# Amendment Report

EnergyConnect (NSW – Eastern Section)

May 2022

Figure 6-12

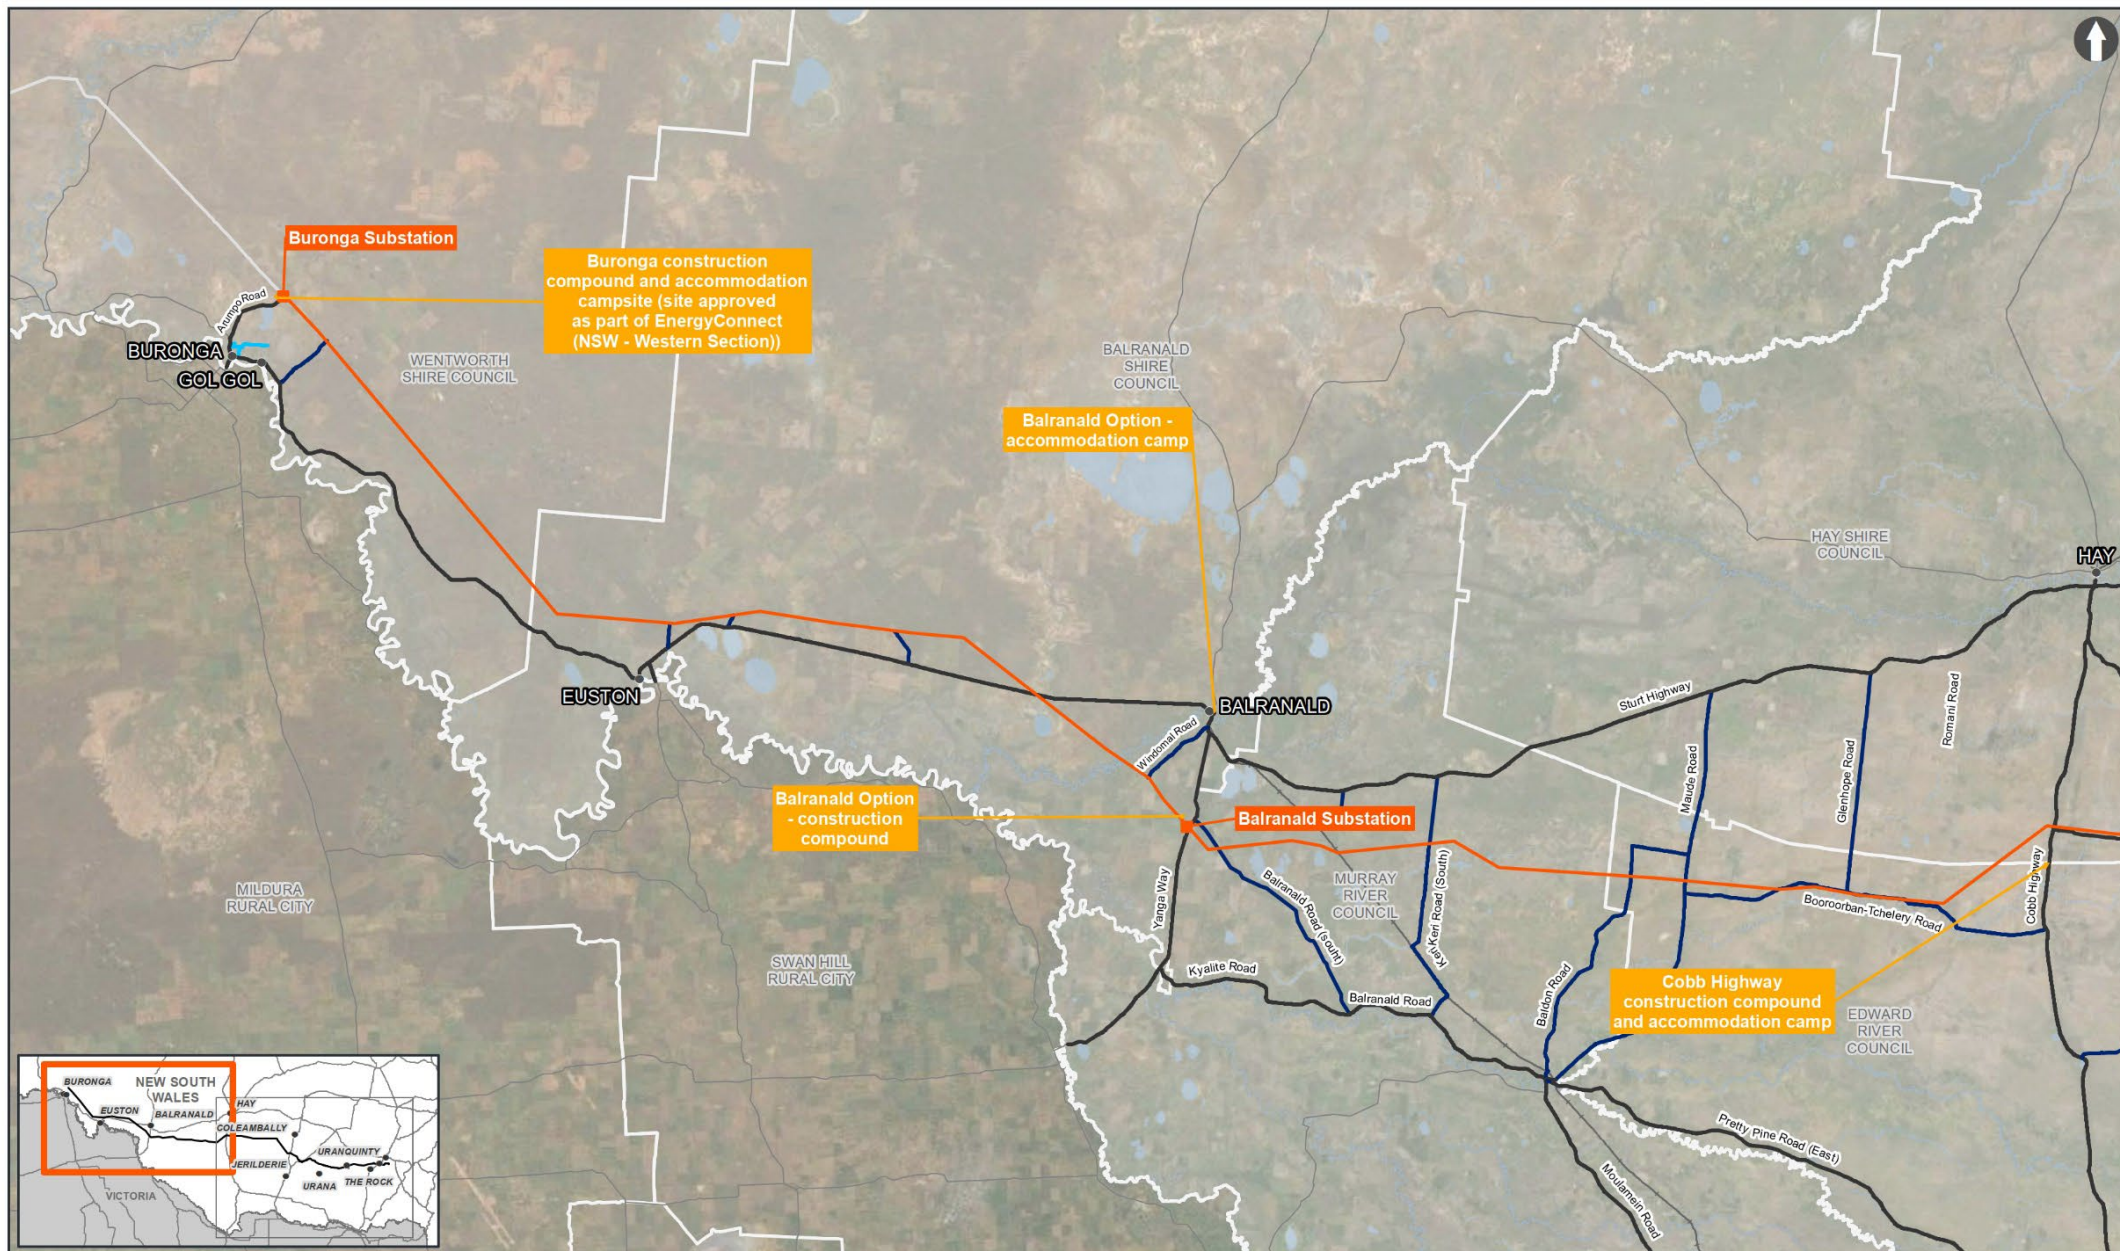
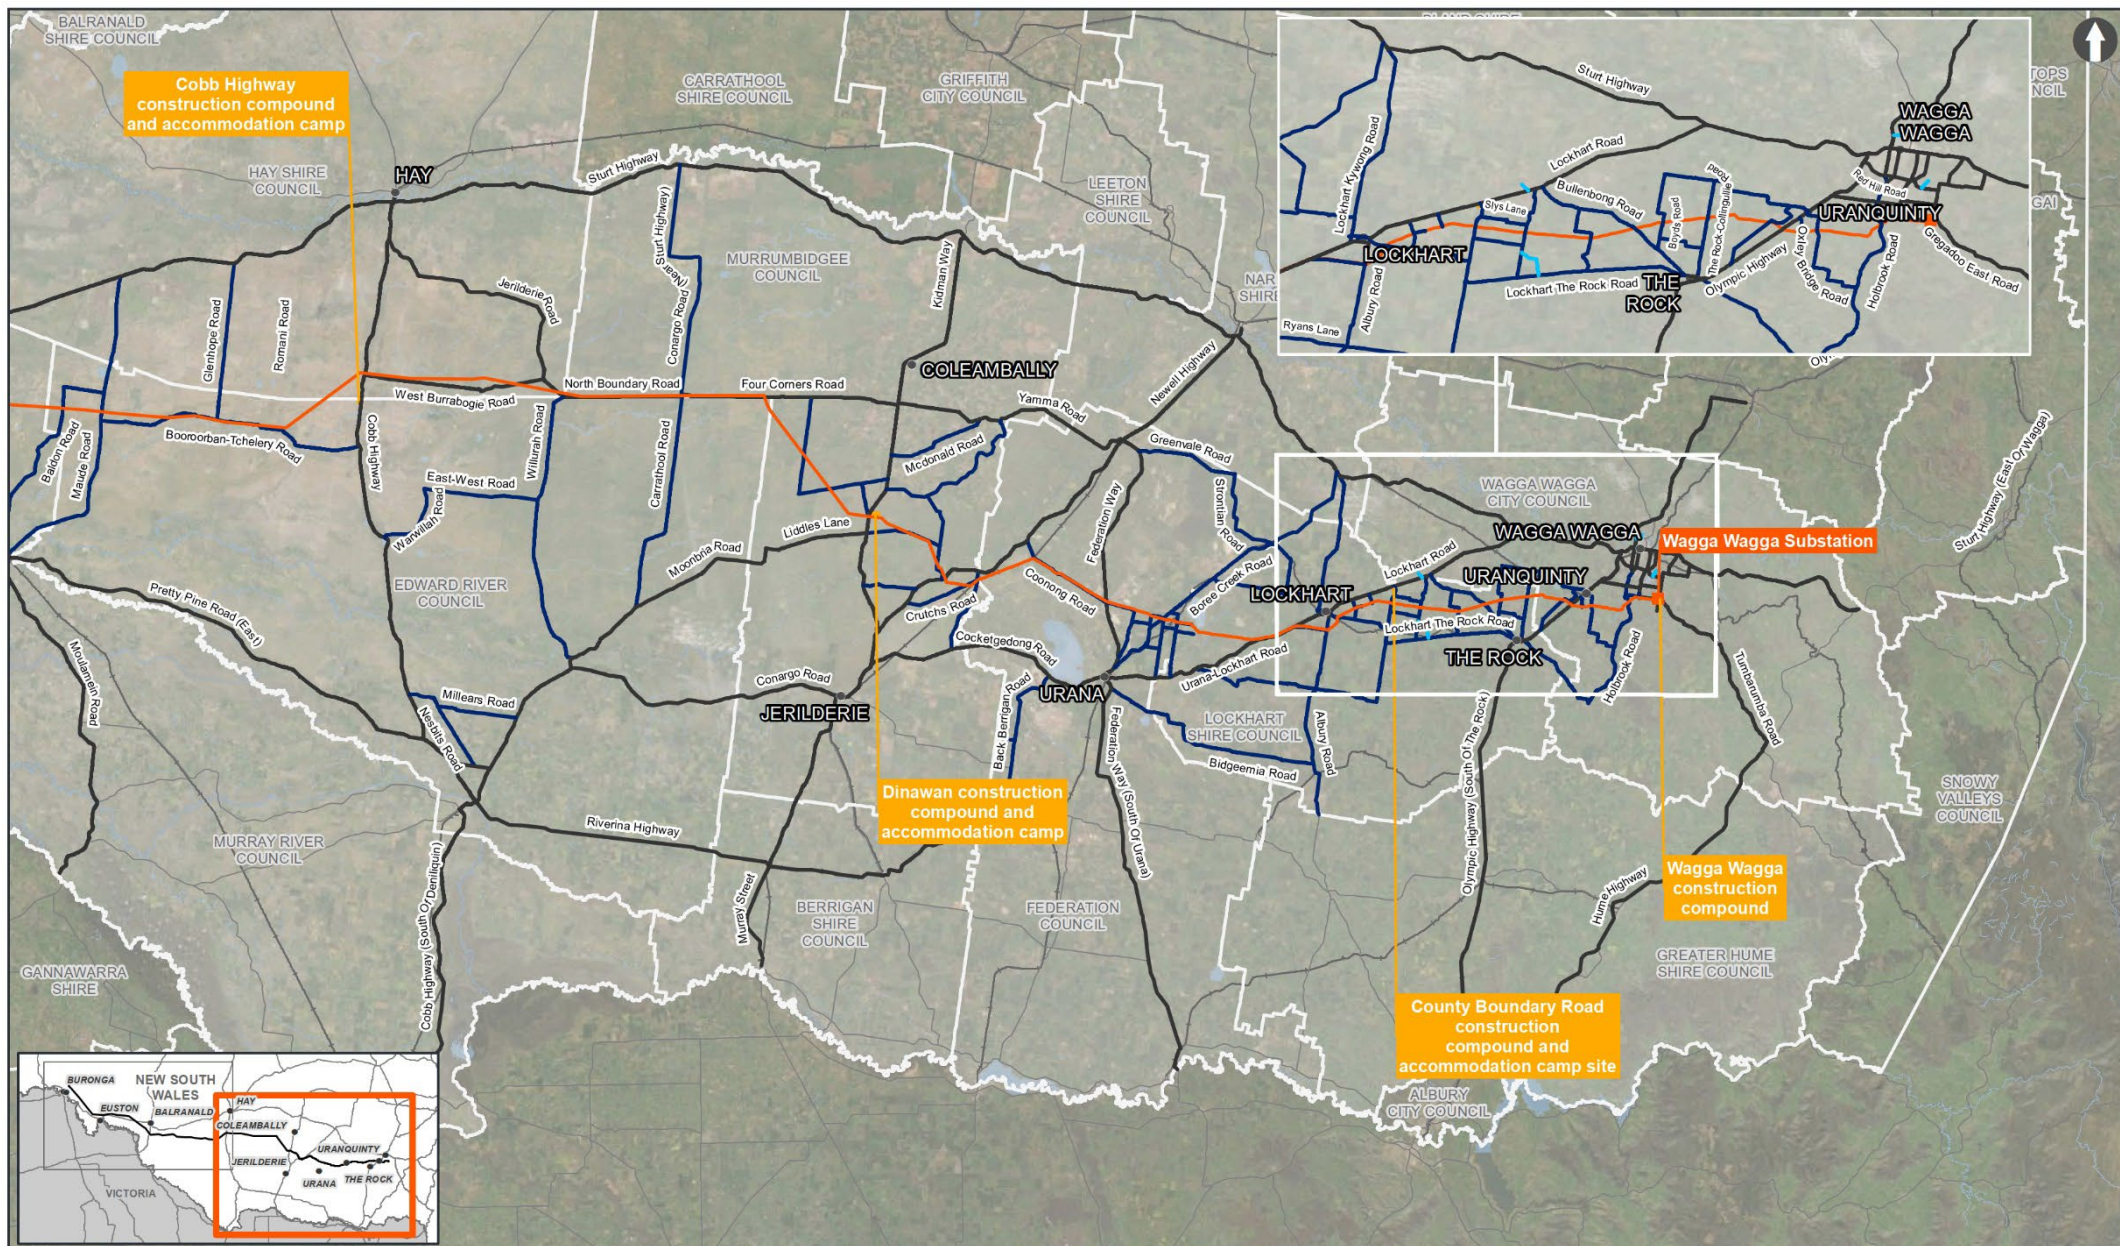
In addition to the below changes, Figure 6-12 of the EIS (refer to Appendix B) has now been corrected to show the full length of Morundah Road within the Murrumbidgee local government area. This regional sealed road, alongside other connecting roads (such as Yamma Road) provides an east-west corridor between Kidman Way and the Newell Highway and road further east.
